Sundry Print Report

Well Name: PINTA 28/29 B3KL FED

Notice of Intent

Type of Action: APD Change

ACREAGE DEDICATION PLATS

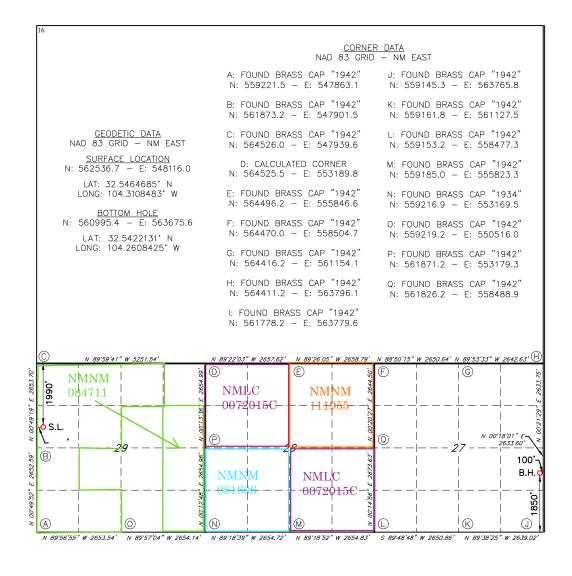
- 1. Change name from Pinta 28/29 B3KL Fed Com #1H to Pinta 29/27 Fed Com #716H.
- 2. Change Dedicated Acreage to 1920 acres.
- 3. Change casing design from 4-string to 3-string.
- 4. Change lateral hole size from 6.125" to 8.50".
- 5. Change Production and Liner casing to a tapered 7"-to-5.5" long string.

'		200			1000101	100122				LDDT	
Dedicate 1920	Dedicated Acres Infill or Defining Well Defining Well API DEFINING			Well API	Overlapping Spacing Unit (Y/N) Consolidation Code N C						
Order N	Numbers. R	23522, NS	P-2218	1		Well setbacks are und	√ell setbacks are under Common Ownership:				
					Kick (Off Point (KOP)					
UL	Section	Township	Range	Lot	Ft. from N/S	Ft. from E/W	Latitude		Longitude	County	
L	29	20S	27E		1850 FSL	_ 10 FWL	32.5424414	4 -	104.3120371	EDDY
